Land East of J11, M40, Banbury Supplementary Environmental Information Volume 2: Appendices

Land East of Junction 11 of the M40, Banbury

Transport Assessment Addendum

26th October 2022
SJT/RT/23457-06f Transport Assessment Addendum

JOB TITLE		LAND AT M40 J11		CLIENT		GREYSTOKE	
DRAWING TITLE							
M40 Junction 11 Gyratory							
SCALE	DRAWN BY	DATE	DRAWING No	REVISION			
1:1000@A1	RM	04/10/22	23459-06-02-GA	A

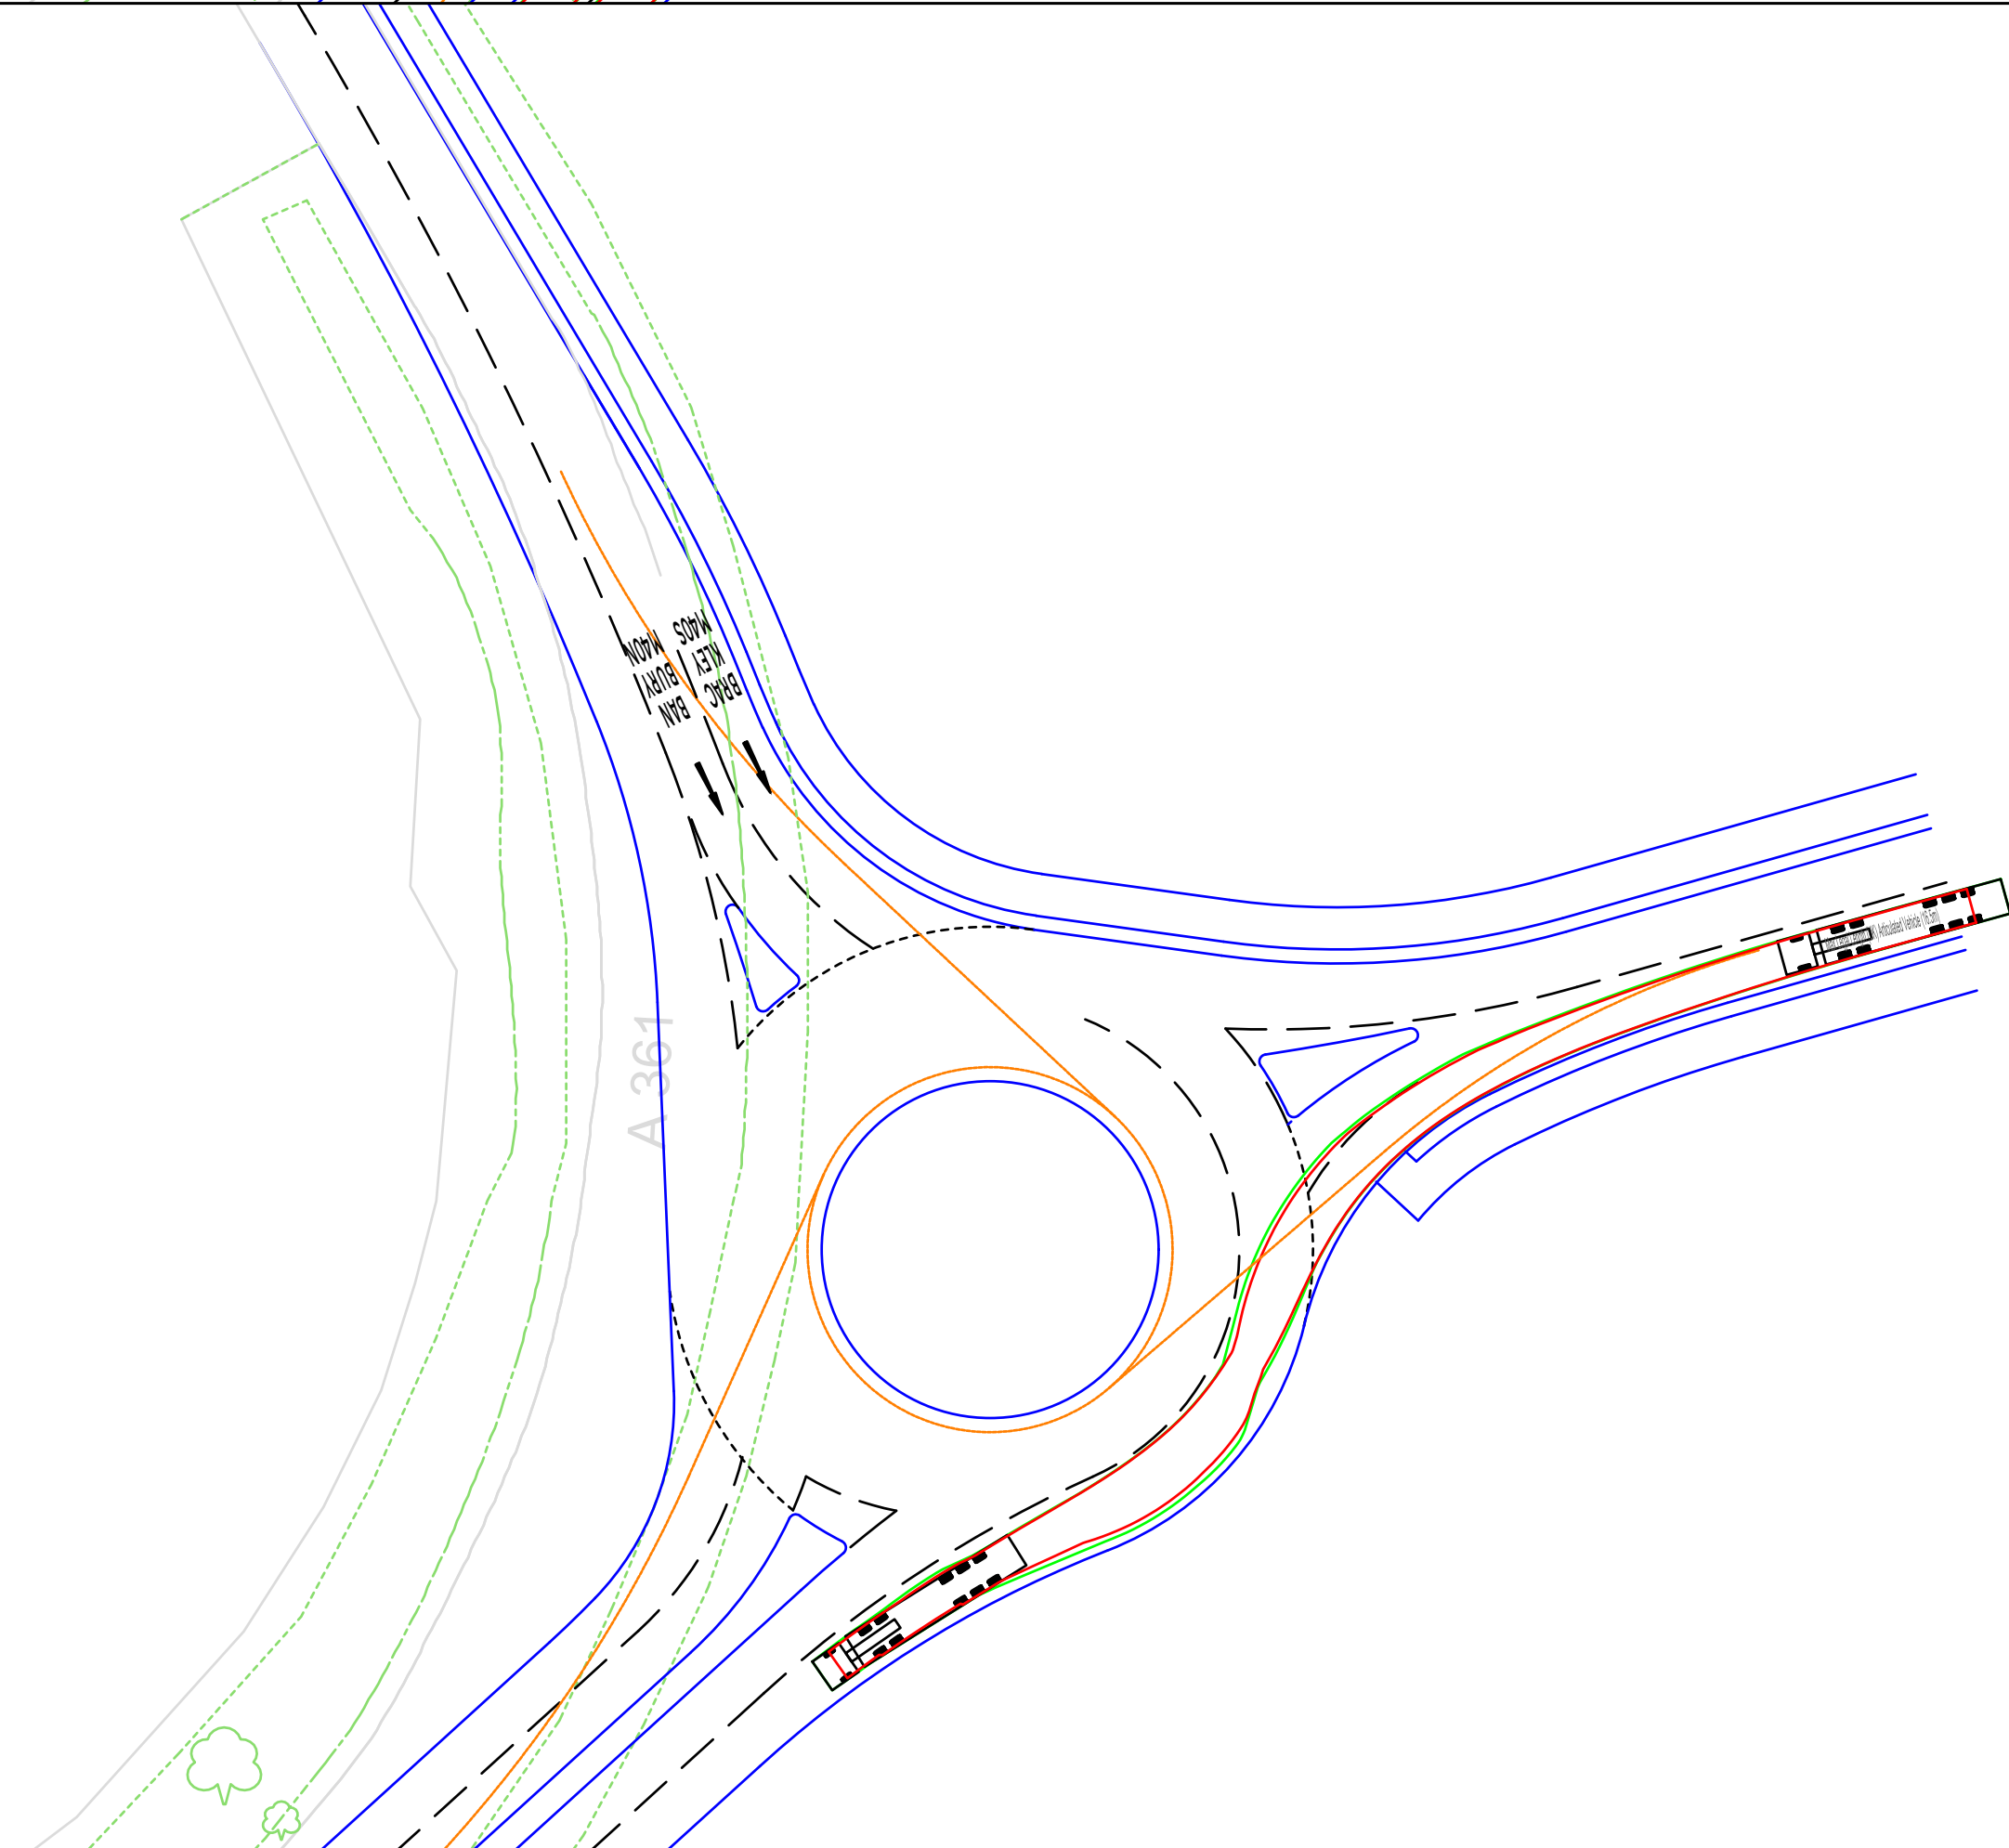
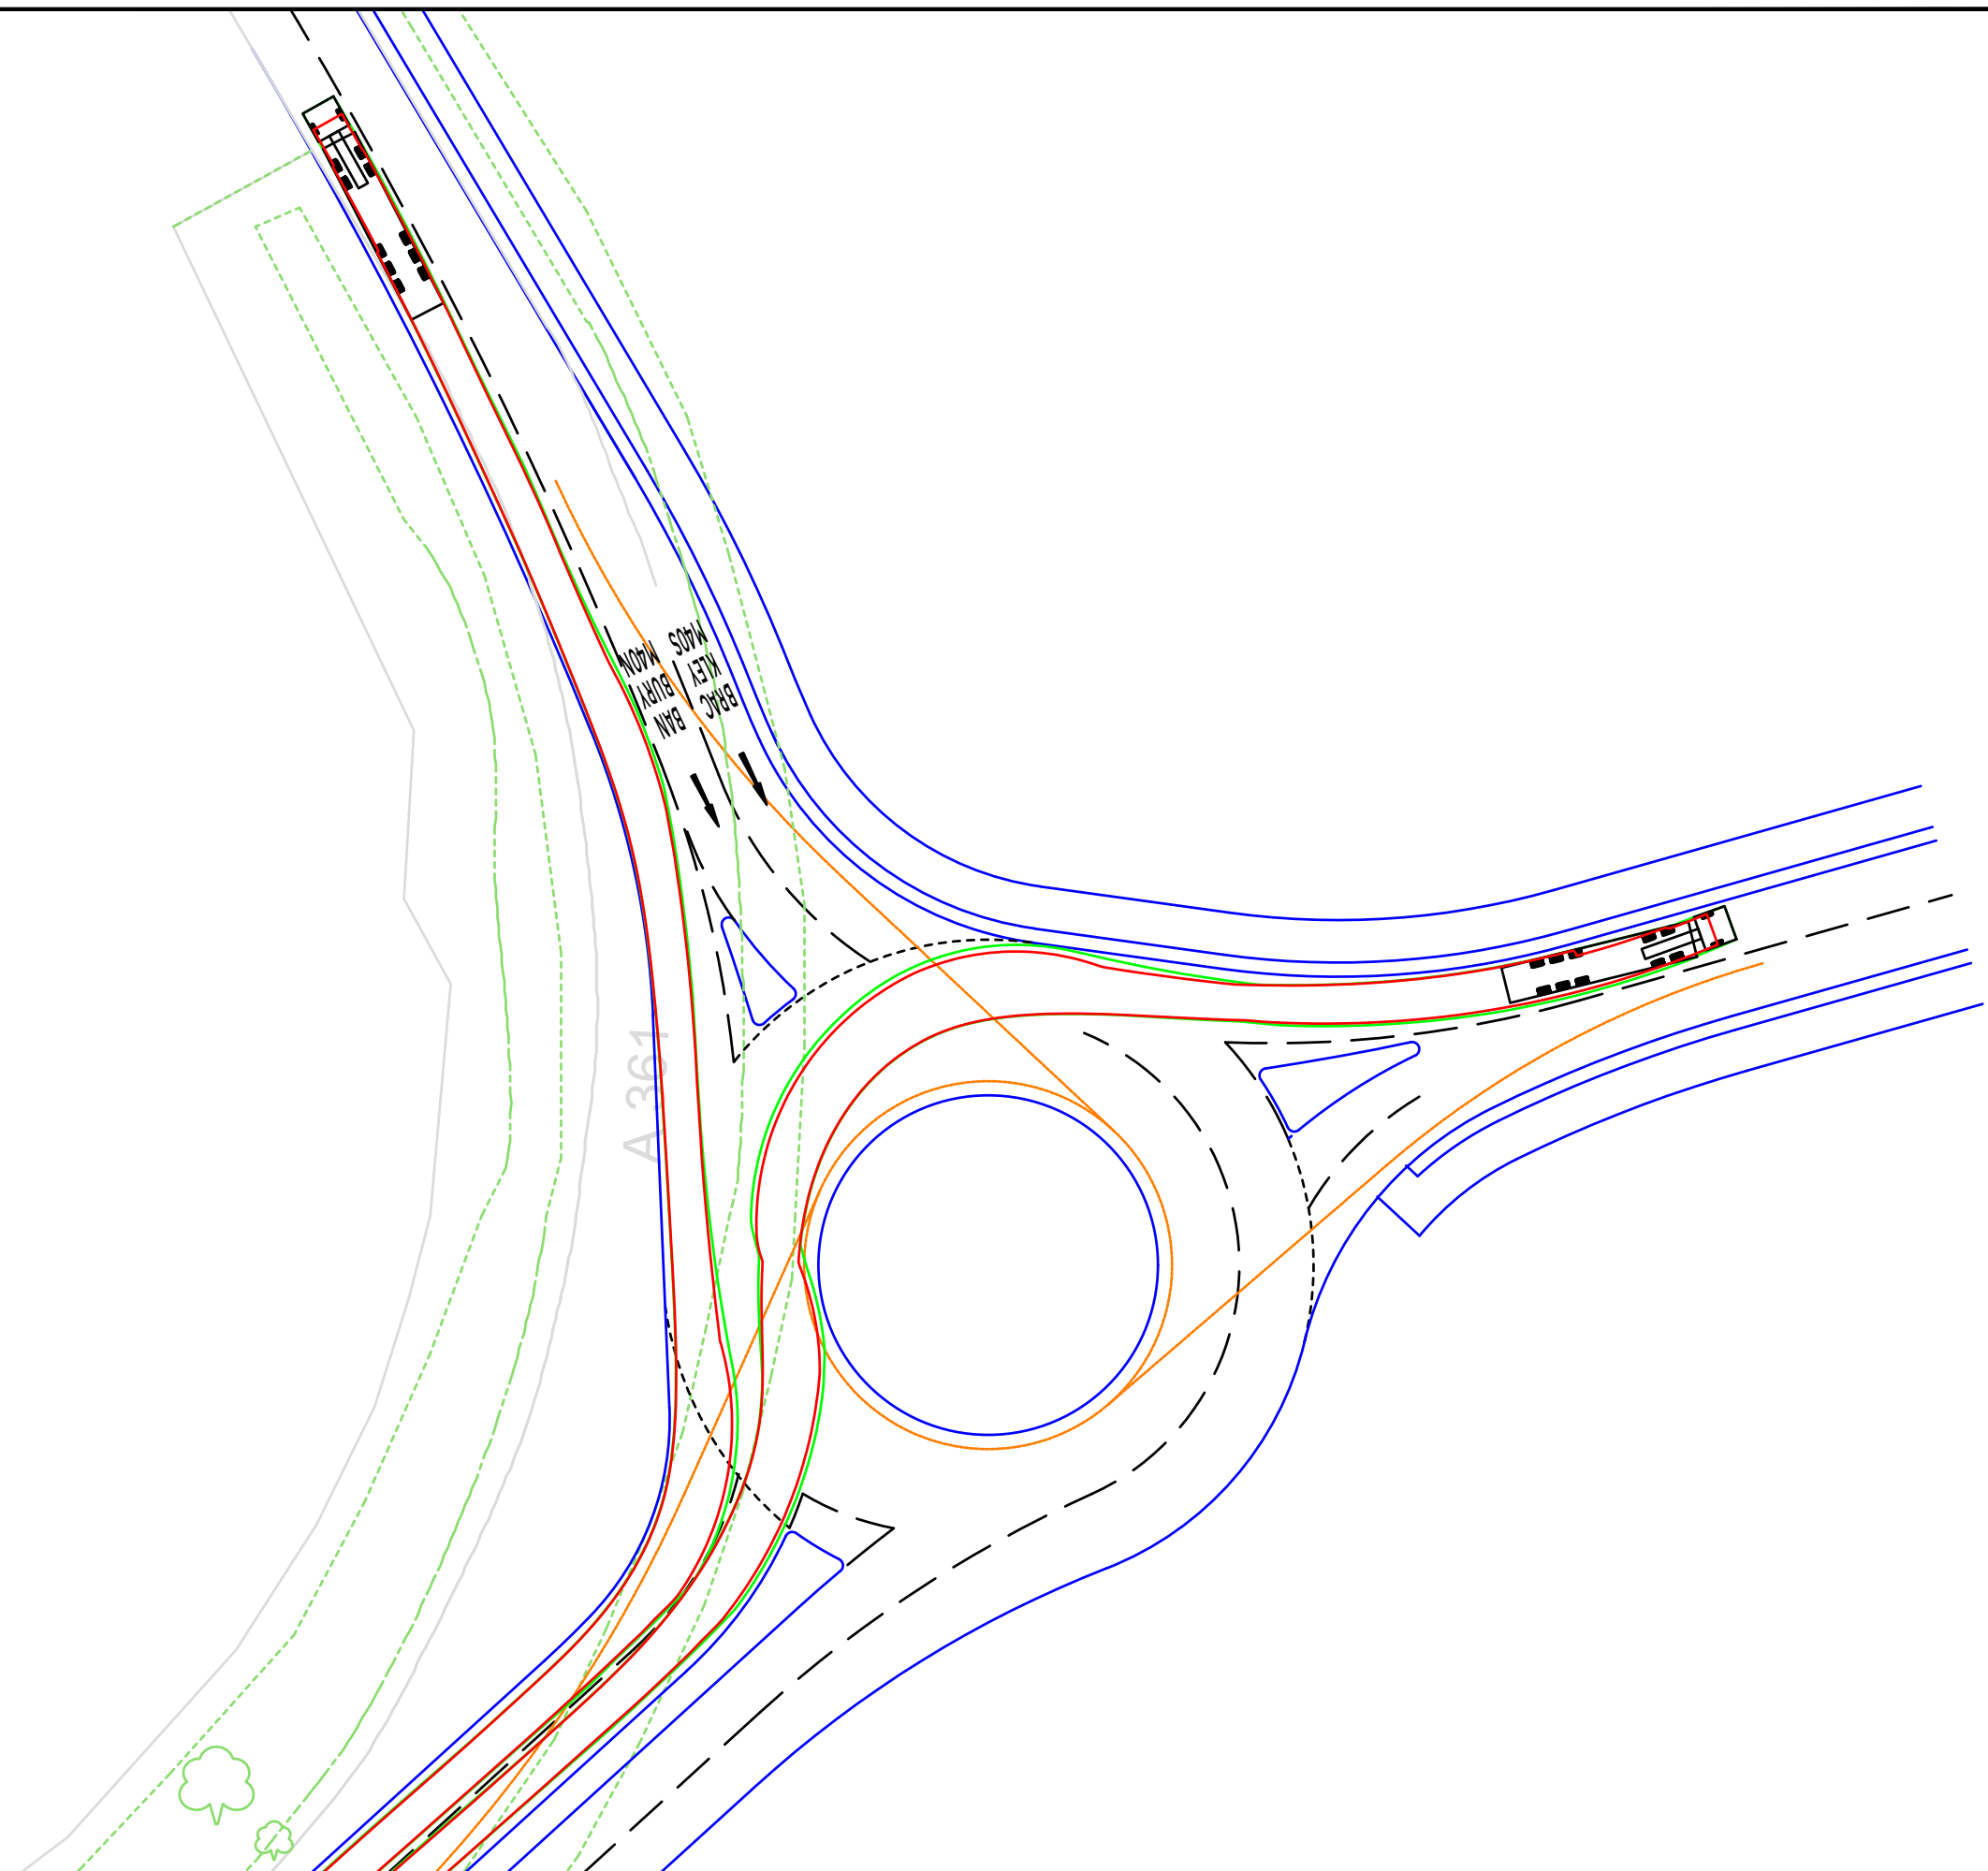
length of queues and the resulting congestion in the area. It has not been demonstrated in a VISSIM simulation that widening the A361 to two lanes between the proposed and existing roundabouts, and increasing the gyratory entry flare to three lanes, is sufficient to mitigate for the effect of the additional vehicles. Also, it has not been demonstrated that these proposed highway modifications are feasible, considering the level differences between the carriageway and the surrounding land.

demonstrated in a VISSIM simulation that widening the A361 to two lanes between the proposed and existing roundabouts, and increasing the gyratory entry flare to three lanes, is sufficient to mitigate for the effect of the additional vehicles. Also, it has not been demonstrated that these proposed highway modifications are feasible, considering the level differences between the carriageway and the surrounding land. Indicative cross-sections and the relation to the highway boundary should be included.

- 1.6 Significant improvements are proposed to improve the operation of the M40 Junction 11 gyratory. To ensure that the site access will operate efficiently the increase in performance addresses significant queueing forecast on the A361 arm. The applicant agrees to the obligation to deliver these improvements via a S278 agreement. The proposed plans can be seen in **Drawing 23457-06a-02-GA** with the associated vehicle tracking in **Drawing 23457-06a-04-TRK**.

- 9.12 The proposed mitigation will provide an additional entry lane and significantly more stacking space. As can be seen in **Table 5** the performance of the junction is significantly improved and the potential for queuing has significantly reduced relative to the baseline. The mitigation therefore more than offsets the development demand. With respect to an interaction between the junctions, this is unlikely to occur in practice as the layout of the site access provides significant spare capacity to maximise its resilience.

- 9.13 The widening of link between the site access and the adjacent gyratory requires additional land only from within the site boundary and there is no constraint to the ability to provide the required side slopes.
- 9.14 To further improve the performance of the A361 arm, the entry can be signalised. This has been modelled on the basis of two entry lanes (rather than the three that would
